Service Bulletin

Bulletin No.: PI1257

Subject: Revised Upper Intake Manifold with Relocated MAP Sensor for DTC P0106

Models: 2007–2009 Chevrolet Silverado
2007–2009 GMC Sierra
Equipped with 6.6L Duramax Diesel Engine (RPO LMM)

3714283

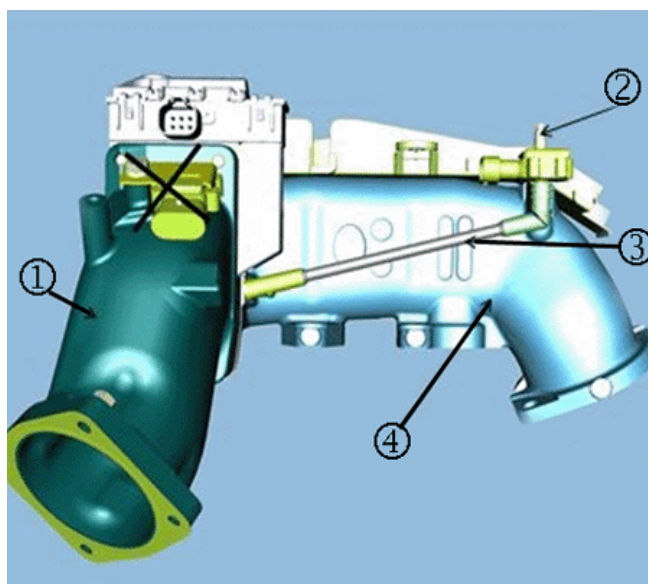
During 2009 production the MAP sensor was relocated from the intake pipe to the upper intake manifold to prevent ice from building up in the MAP sensor and setting DTC's. The MAP sensor on this new design was located on the top of the upper intake manifold and connected through a hose which connects to a pressed in hose barb. The old design upper intake manifold without the hose barb is no longer available.

If an upper intake manifold is ordered, it will be of the new design. This hose barb can be plugged with a second MAP sensor and the MAP sensor tube if there have been no icing issues, or the harness can be extended from the old sensor to the new sensor location to reduce chances of icing.
